Technical Bulletin

Timing Belt System replacement on VAG 1.8 20V engines (PowerGrip® Belt and Kits 5492XS)

GATES REFERENCE :	PowerGrip and kit 5492XS	
MAKE :	AUDI / VOLKSWAGEN	
MODEL :	A4, A6, Cabrio, Passat	
MOTOR :	1.8, 1.8 – 20v T	
MOTOR CODE :	AEB, ADR, AFY, AJL, ANB, ARG, ARK, APT, APU, AVV

Fig. 1 new system

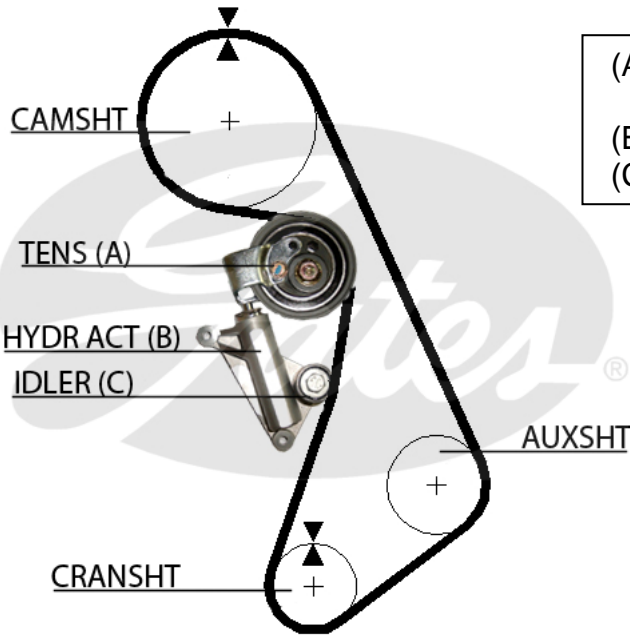
Originally the VAG 1.8 20V engines were equipped with OE belt 058109119A/058109119D (5425XS - 152 teeth), tensioner pulley 058109243B and a thermal compensating actuator⁽¹⁾ 058109479 (old system).

After durability problems it was decided to reengineer the synchronous system and to use an OE belt 058109119B/058109119C (5492XS - 153 teeth) together with a hydraulic actuator⁽²⁾ 058109479B and a new tensioner pulley 058109243E (new system – Fig. 1).

Note: The old system is no longer available on OES level. It is strongly recommended to replace the entire system with the new system (Fig. 1) when the original timing belt needs replacement. Please make sure that parts of the old and new system are not being interchanged in order to avoid engine damage.
